UNITED STATES
NUCLEAR REGULATORY COMMISSION
WASHINGTON, D. C. 20555

Amendment No. 61
License No. DPR-42

Amendment No. 55
License No. DPR-60

SAFETY EVALUATION BY THE OFFICE OF NUCLEAR REACTOR REGULATION
RELATED TO AMENDMENT NO. 61 TO FACILITY OPERATING LICENSE NO. DPR-42
AND AMENDMENT NO. 55 TO FACILITY OPERATING LICENSE NO. DPR-60
NORTHERN STATES POWER COMPANY
PRAIRIE ISLAND NUCLEAR GENERATING PLANT, UNIT NOS. 1 AND 2
DOCKET NOS. 50-282 AND 50-306

FIGURE TS.6.1-2 PRAIRIE ISLAND NUCLEAR GENERATING PLANT FUNCTIONAL ORGANIZATION FOR ON-SITE GROUP

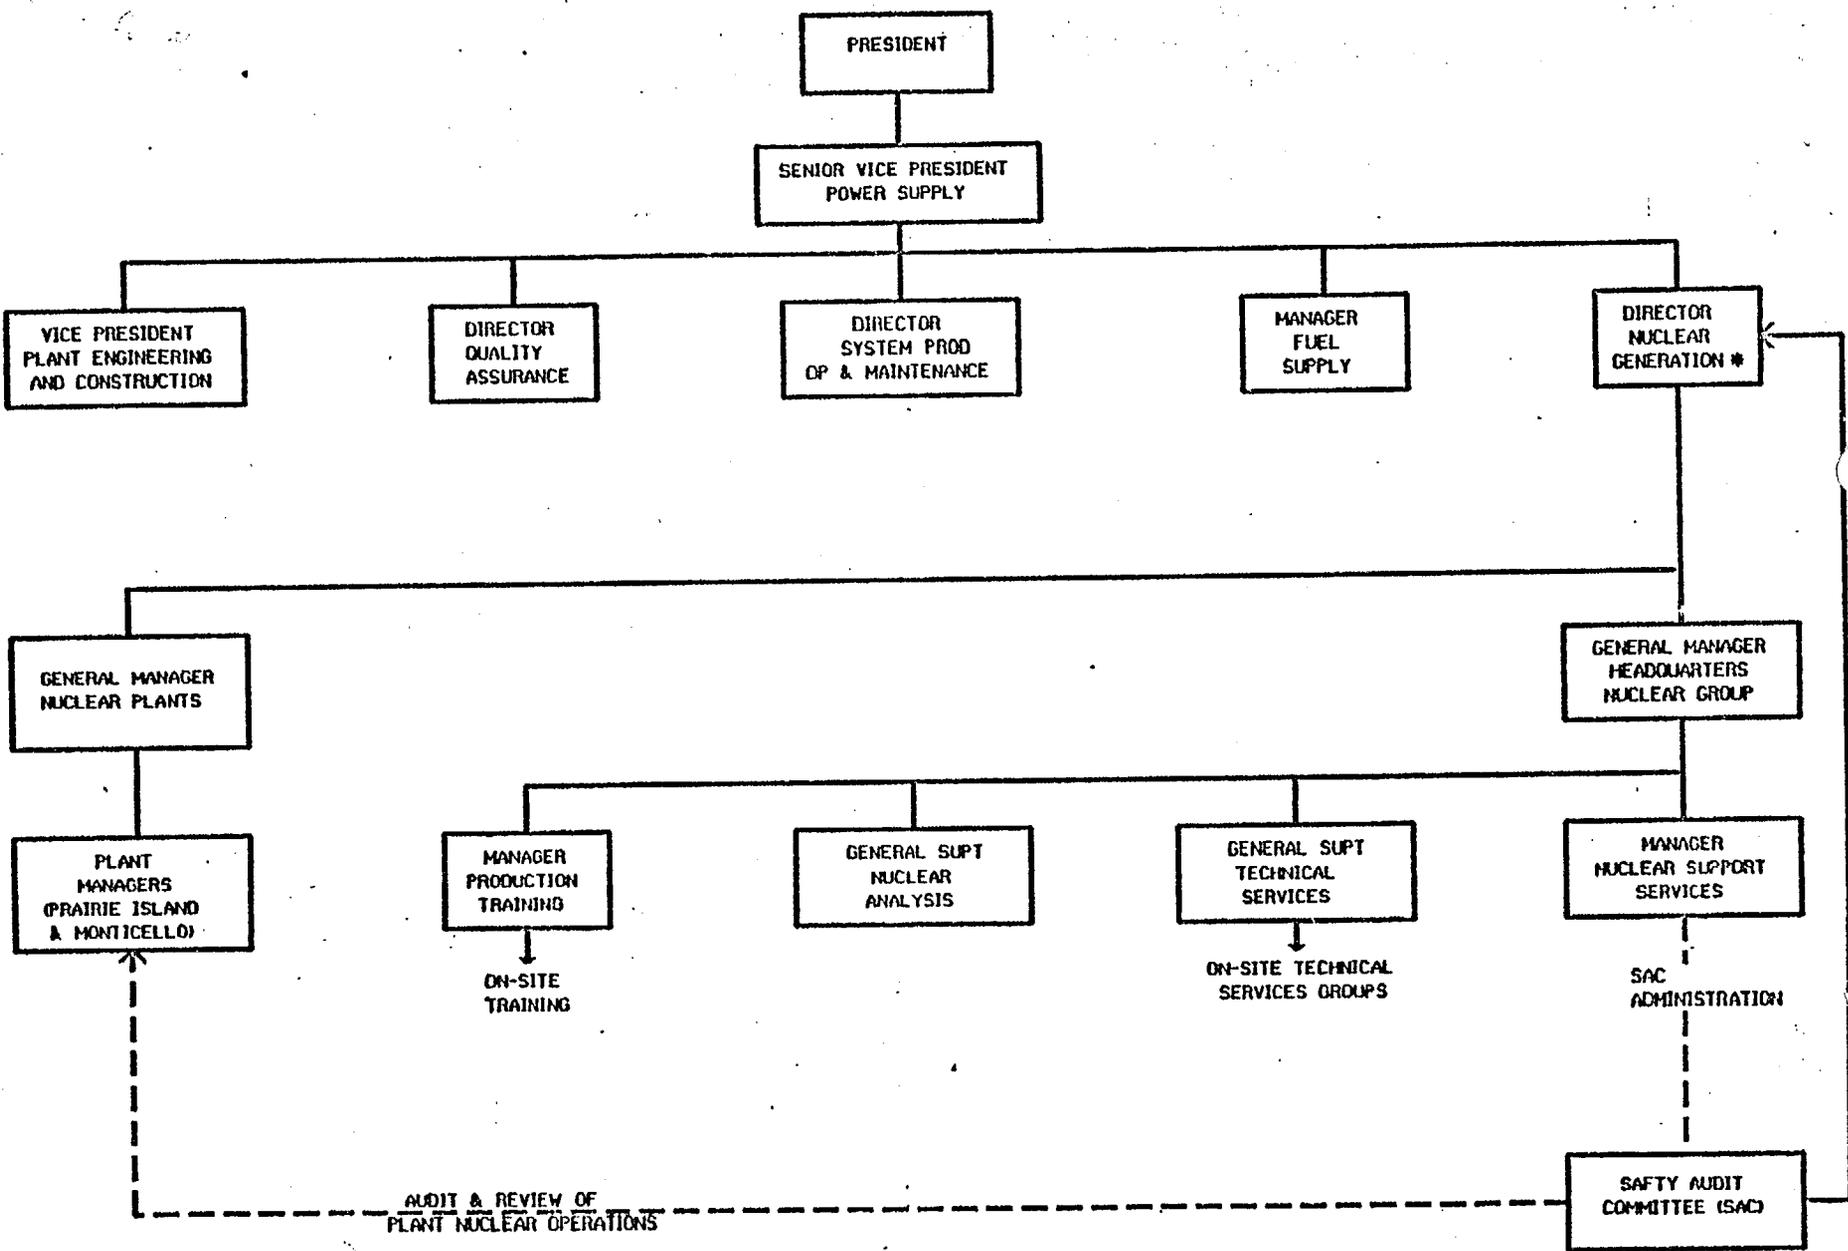
The licensee has proposed to update the NSP Corporate Organization Chart Figure TS 6.1-1 to reflect the recent organization changes. Other changes include position title changes on pages TS 6.2-1, TS 6.2-3 and TS 6.2-5 to reflect title changes of various positions. The licensee requested to replace Figure TS 6.1-2 with a redrawn figure.
